**Planning Application 2016/0427/OUT - Objections to the proposal by St Athan Community Council following general meeting on January 10<sup>th</sup> 2017**

APPENDIX A

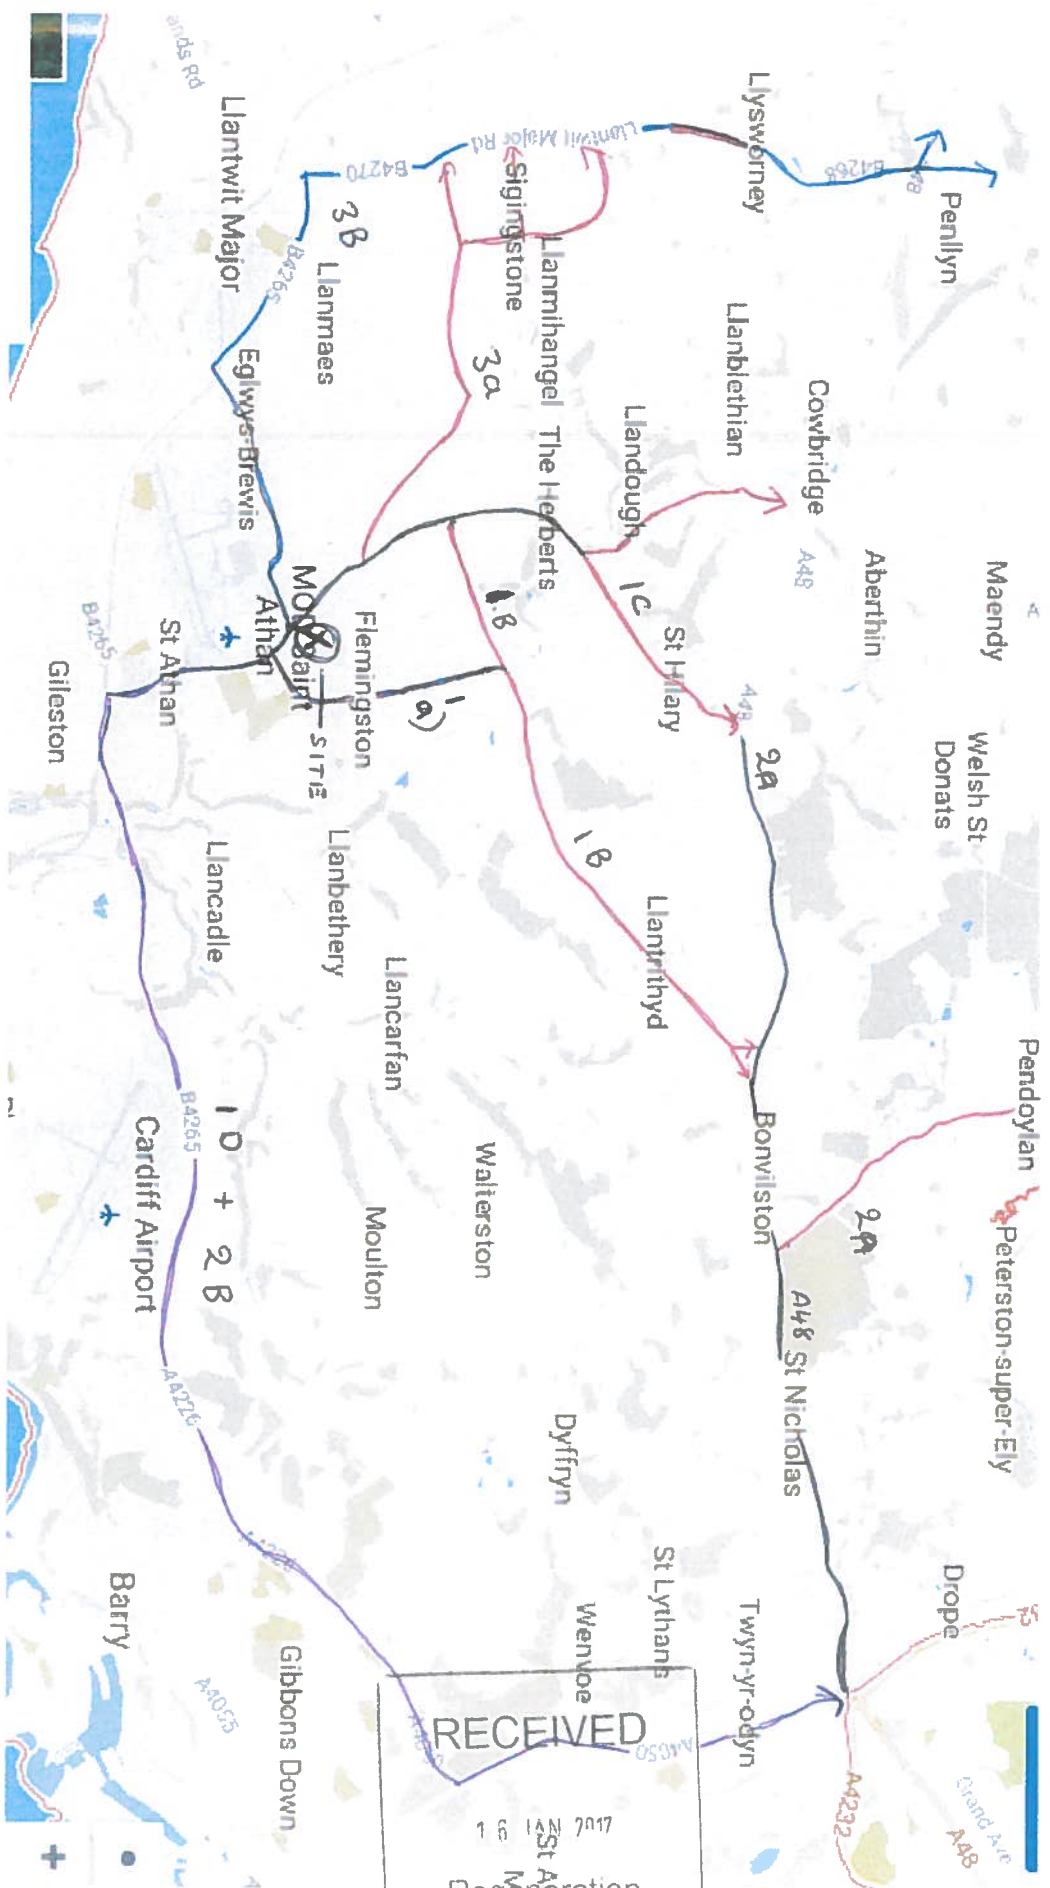
Routeplanner Routes from the location of this development.

For this exercise 'The Gathering Place' was used as the initial location.

- 1) Routes to Culverhouse Cross, Cardiff.
  - a) 8.9 miles – Flemingston Road via Flemingston Village – Llantrithyd – A48
  - b) 9.6 miles – Cowbridge/St Athan Road via St Mary Church X roads – Llantrithyd – A48

- c) 10.2 miles – Cowbridge/St Athan Road via The Herberts – St Hilary – A48
  - d) 11.3 miles – St Athan Village – B4265 – Port Road.
- 2) Routes to M4 East (Cardiff)

- a) 10 miles - Cowbridge/St Athan Road via The Herberts – St Hilary – A48 – Bonvilston – Hensol Junction 34
  - b) 16.6 miles - St Athan Village – B4265 – Culverhouse Cross – M4 Junction 33

- 3) Routes to M4 West (Pencoed) via Pentre Meyrick – St Mary Hill
  - a) 11.4 miles – Cowbridge/St Athan Rd via lanes New Barn towards Siginstone – B4270 Llandow – Llysworney – A48 – Pentre Meyrick

- b) 12 miles – Eglwys-Brewis Road – Boverton – B4270 – Llysworney – A48 A48 – Pentre Meyrick (note this will be a similar situation if the Northern Access Road is built)

- i) When MOD St Athan was a fully functioning RAF base that the official allowed routes were 1 d, and 3 b.
- ii) The RED routes in the plan all have large sections of single way very rural lanes.
- iii) The Port Road routes 1d and 2b, are already very highly congested, which has been further compounded by new bus lanes.
